Department of Environmental Quality

Re: Long-Term Ground Water Quality Concerns based on
Review of the Application for Alternate Concentration Limits (ACLs)
TFN 3 3/122

MEMORANDUM

TO: Georgia A. Cash, District I Supervisor
FROM: Roberta N. Hoy, Geohydrologist *RNH*
DATE: May 1, 1999
RE: Review of Bear Creek ACL Application - TFN 3 3/122

FIGURE 3
WELL LOCATIONS NEAR TAILINGS

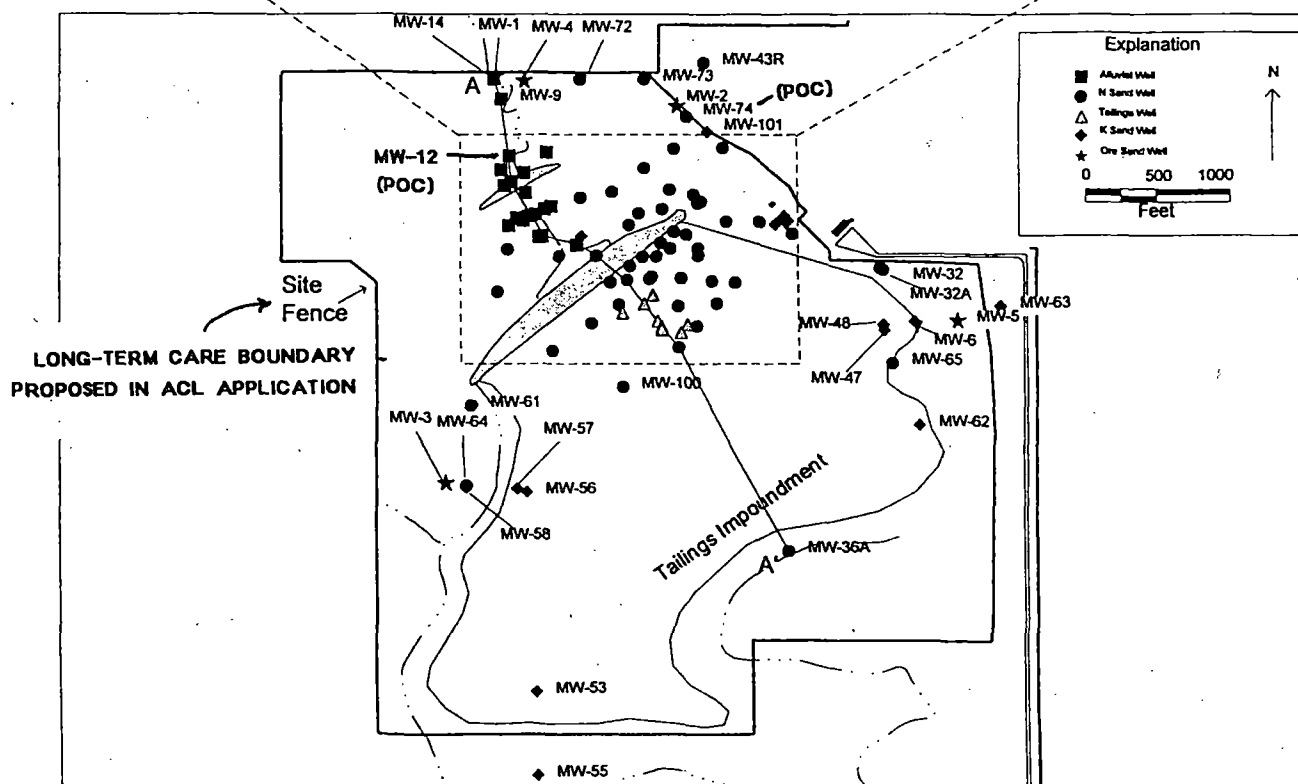
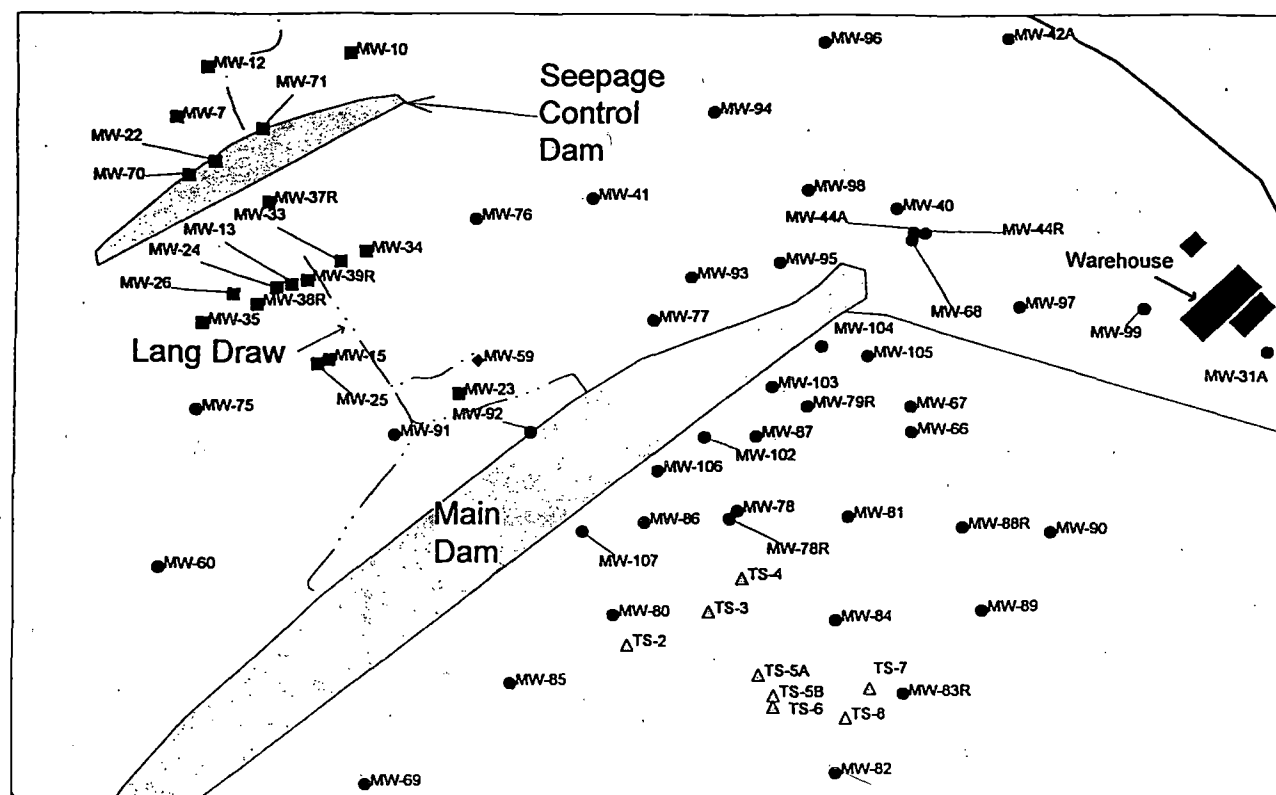
5.3 Lateral Migration. The limited lateral migration is best illustrated by wells along the western edge of the tailings, in particular Wells MW-56, MW-57, MW-58, MW-60, MW-61, and MW-64 (Figure 3). Wells MW-56 and MW-57 are both K-Sand wells completed within the tailings impoundment area. Well MW-58 is a K-Sand well just west of Wells MW-56 and MW-57, but outside of the tailings impoundment area. Water levels in both Wells MW-56 and MW-57 declined rapidly during the tailings dewatering, but the water level in Well MW-58 has remained relatively constant (Figure 8). Sulfate concentrations in all three wells are relatively low, on the order 1,000 to 3,000 milligrams per liter (mg/l), in comparison with the sulfate concentrations in the tailings solution on the order of 18,000 to 20,000 mg/l (Figure 9).

Wells MW-60, MW-61, and MW-64 are all completed in the N-Sand. Well MW-60 is just north of the tailings dam; Well MW-61 is on the northwest corner of the tailings dam; and Well MW-64 is to the west of the tailings. Water levels in all three wells have declined rapidly during the seepage recovery (Figure 10). The sulfate concentrations in Well MW-60 are the highest, on the order of 1,500 to 2,000 mg/l, and the concentrations in Well MW-61 and MW-64, which are on the order of 500 to 1,000 mg/l (Figure 11). These concentrations are an order of magnitude less than the sulfate concentrations in the tailings solution (18,000 to 20,000 mg/l) and in Well MW-77 (10,000 to 14,000 mg/l), which is an N-Sand well in the vicinity of the dam leak (Figure 3).

Even without considering leakage through the tailings, the LQD was concerned that the conditions at the Long-Term Care Boundary proposed in the ACL application (Figure 3) would not be in compliance with LQD's goals for baseline conditions or, at a minimum, 'class-of-use' conditions at the boundary. The concentrations of the ACL parameters, radium, uranium, and nickel, were of some concern; however, the potential concentrations of nonradiological parameters, such as sulfate and chloride, were of greater concern.

The LQD believes four safeguards are necessary to ensure that contaminant movement does not extend outside the boundary. The first safeguard is incorporating additional area into the Long-Term Care Boundary, specifically the area of Section 9 currently owned by Bear Creek, to the north of the Long-Term Care Boundary proposed in the ACL application (Figures 2 and 3). This additional area will provide a 'buffer' for continued geochemical attenuation by calcium carbonate within the aquifer materials and a 'margin of error' if some of the predictions prove incorrect. The second safeguard is for ground water monitoring along the two flowpaths, preferably in at least two locations along each flowpath, as well as monitoring the 'endpoints'. This monitoring will provide information to evaluate the accuracy of the predicted contaminant movement. The third safeguard is to include analyses of 'conservative' parameters, such as sulfate and chloride, as well as parameters that should be attenuated in the aquifer. This will allow for evaluation of alternatives if it later appears that concentrations of parameters of concern to the State, as well as those of concern to the NRC, will be exceeded. The fourth safeguard is for a periodic check, such as once every ten years, of the SEO's records to evaluate the changes in water demands in the vicinity of the site. At present, this information can be readily obtained by submitting the location of interest to the SEO. This periodic check will help determine if any new demands on the local aquifers are of concern.

FIGURE 4

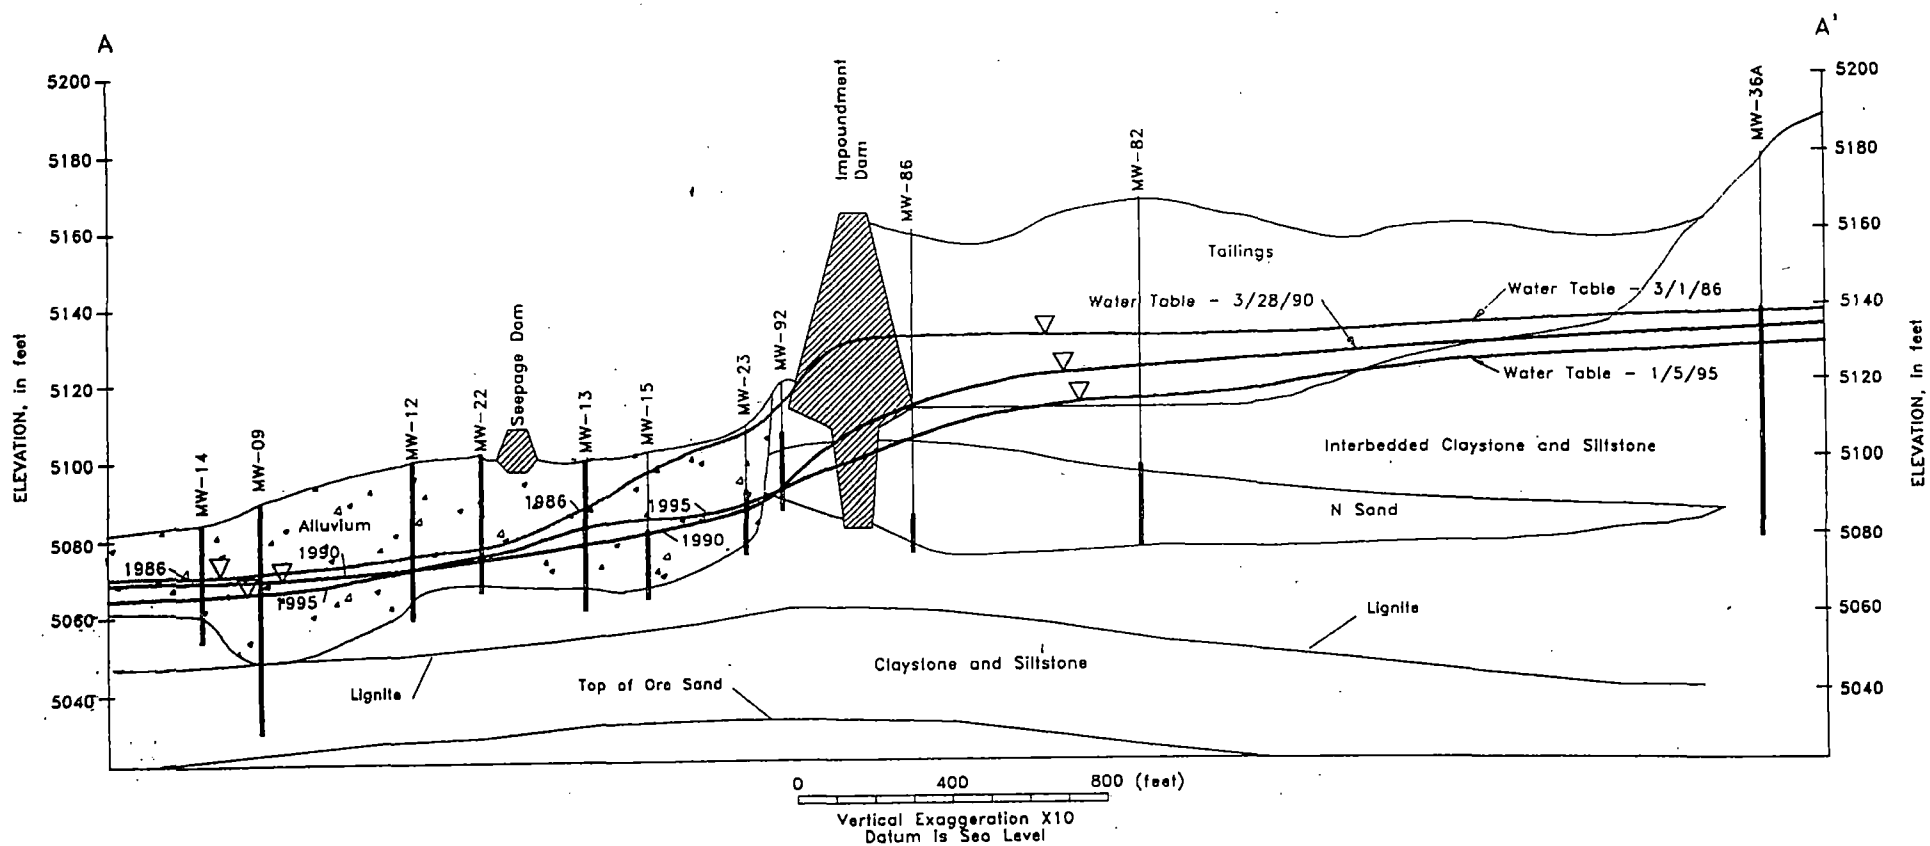
The Ore Sand is separated from the shallower sands by claystones and siltstones (Figure 4). Hydrogeologic and water quality data collected throughout the area during the Bear Creek operations indicates this material is an effective aquitard. (Concerns about the sulfate concentrations in Well MW-2, an Ore Sand well, are discussed in the next section.) In addition, there are no indications that mining activities have created communication through the aquitard in the potential area of impact of the tailings. Therefore, only the sandstone layers in the Wasatch above the Ore Sand were considered in this review.

Figure 5
SO₄ Concentrations vs. Time
Bear Creek - TFN 3 3/122
February 1999

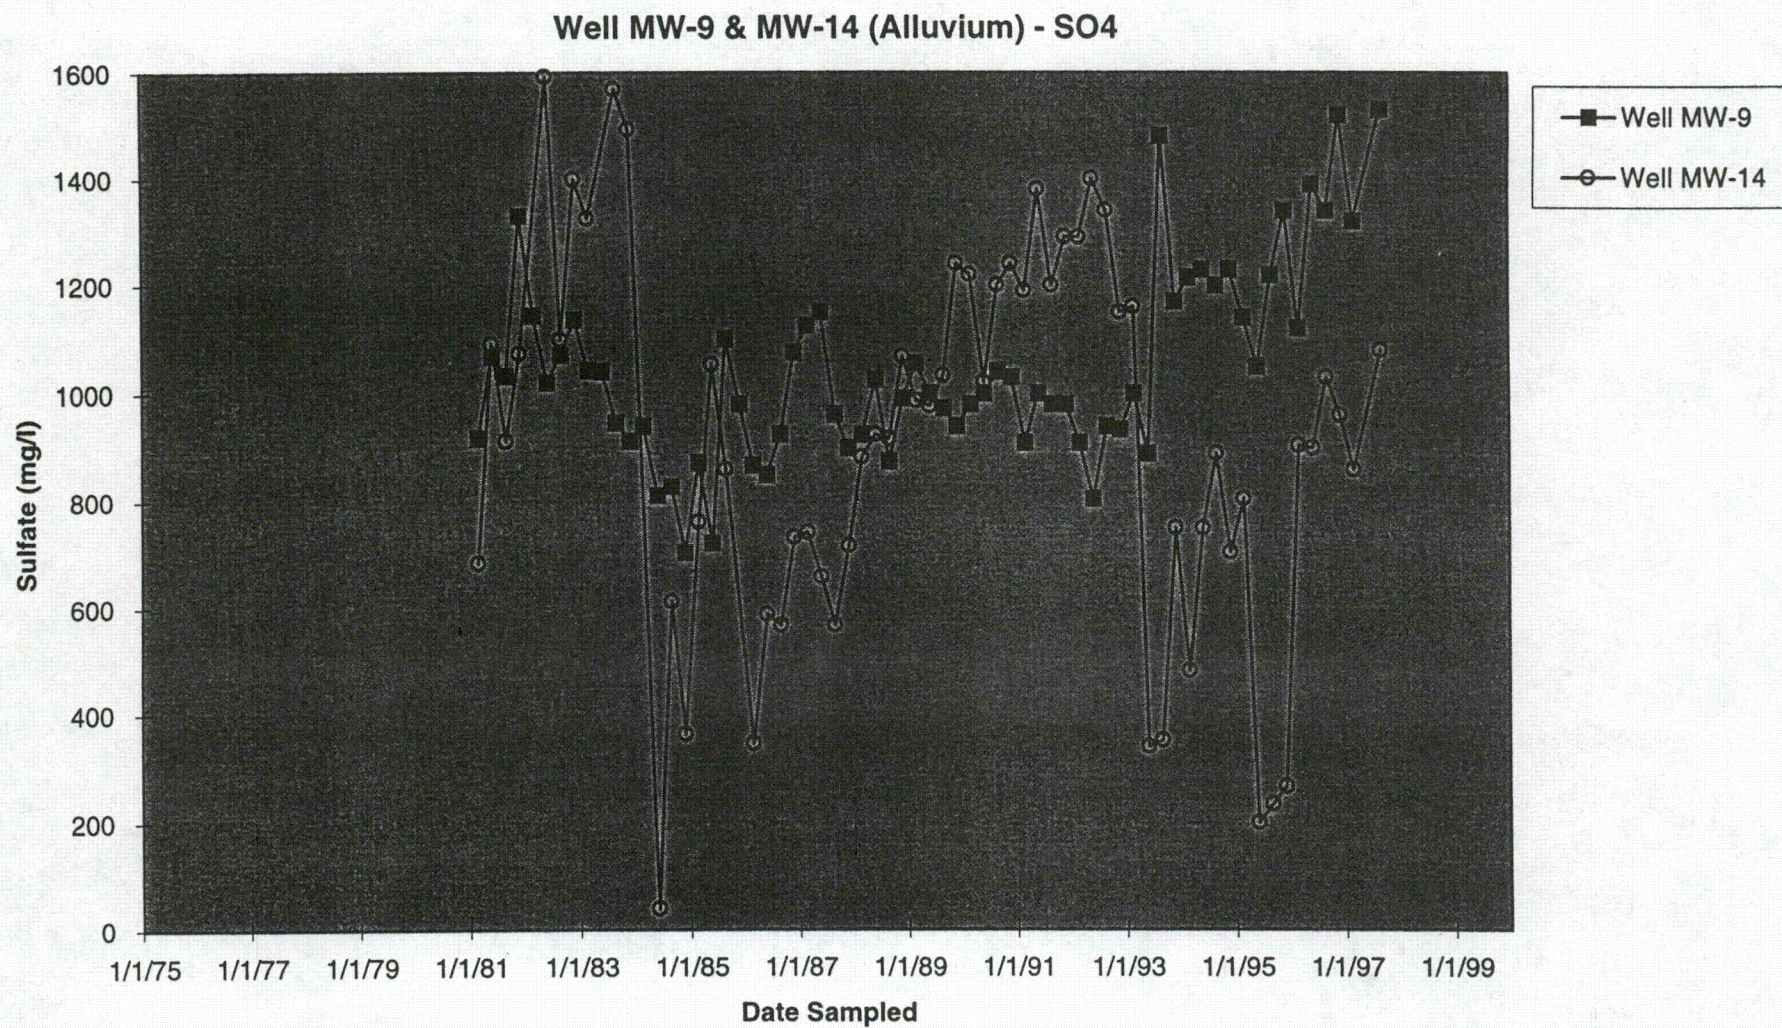
5.1 Lang Draw. Concentration changes in three wells, Wells MW-9, MW-14, and MW-23, raised concern about some of the simplifying assumptions on ground water movement in Lang Draw. For example, the sulfate concentrations in Well MW-9 were relatively steady over time, while the concentrations in Well MW-14 fluctuated significantly, even though both are alluvial wells and are within about 100 feet of one another. The difference was of particular concern because these two wells are near the POC well in Lang Draw (Figure 3). However, Well MW-14 is located in a portion of the draw in which snow drifts, while Well MW-9 is located on the bank of the draw. Therefore, the fluctuations are probably due in part to variations in recharge along the draw during snowmelt. As areal recharge was not taken into account in the predictions of contaminant movement along Lang Draw, the difference between the two wells was not considered critical to the predictions. (Section 6.0 provides additional discussion of the assumptions and conditions used in the predictions.)

Figure 6
SO4 Concentrations vs. Time
Bear Creek - TFN 3 3/122
February 1999

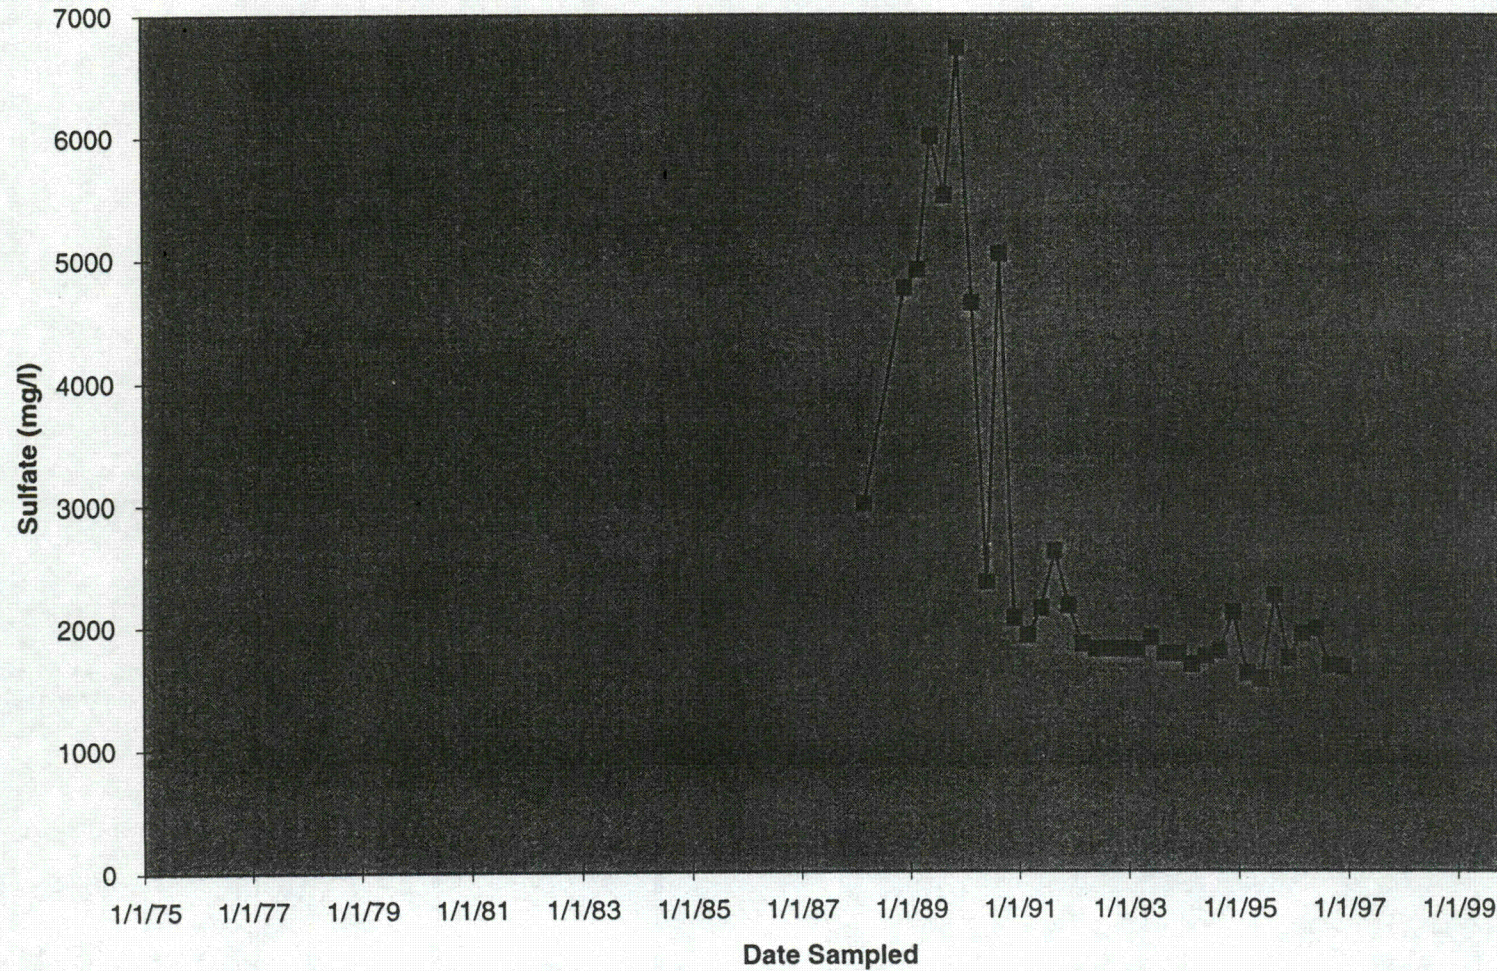
The rapid decline in the sulfate concentration in Well MW-23 was also of concern in case it represented movement of a 'slug' of higher contaminant concentrations past the well (Figure 6). However, Bear Creek indicated that the change in the sulfate concentrations was due to well redevelopment. Prior to 1991, the well was hand-bailed and the samples were described as black, brackish water. After well redevelopment and changing the sampling technique, more consistent data was obtained which was comparable to other wells in the vicinity.

Figure 12
SO4 & Cl Concentrations vs. Time
Bear Creek - TFN 3 3/122
February 1999

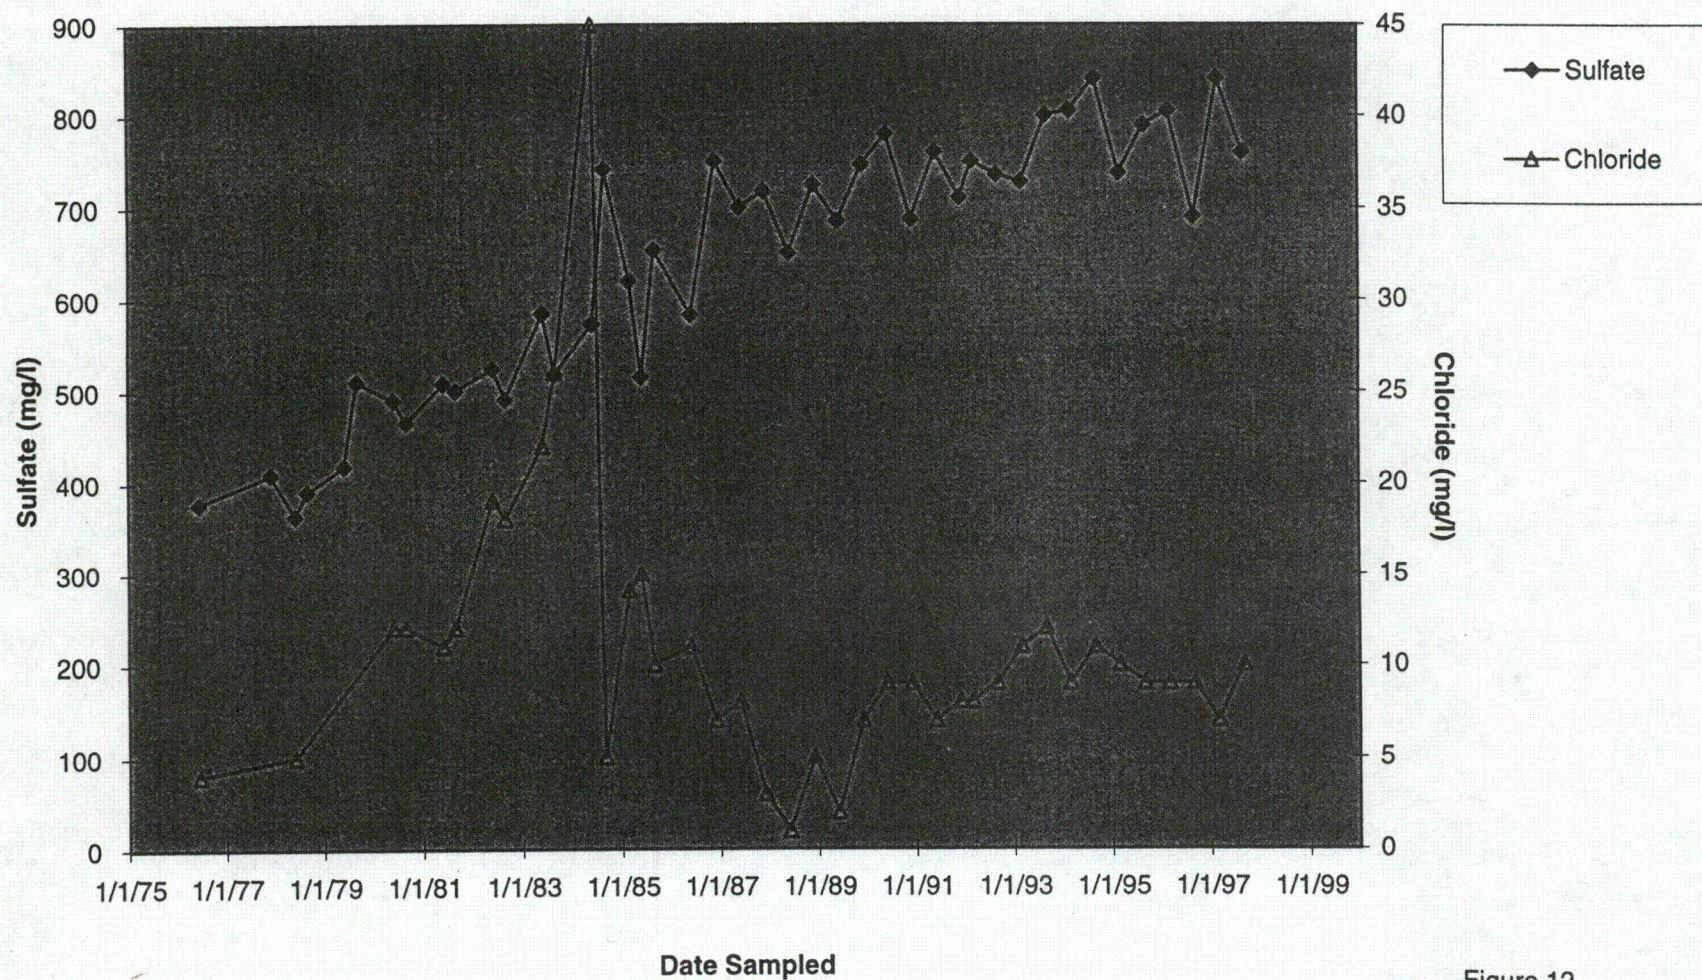
5.4 Ore Sand. Although the aquitard between the Ore Sand and the N-Sand was considered to be an effective aquitard, the increase in sulfate concentrations in Well MW-2 was of concern (Figure 12). The increase could be due to the influence of mining of the Ore Sand; however, it could have also been due to leakage through the aquitard in the vicinity of the well or due to poor well completion. However, there was no corresponding increase in chloride concentrations in the well. Therefore, the increase is considered to be due to the influence of mining, not due to the influence of tailings leakage.
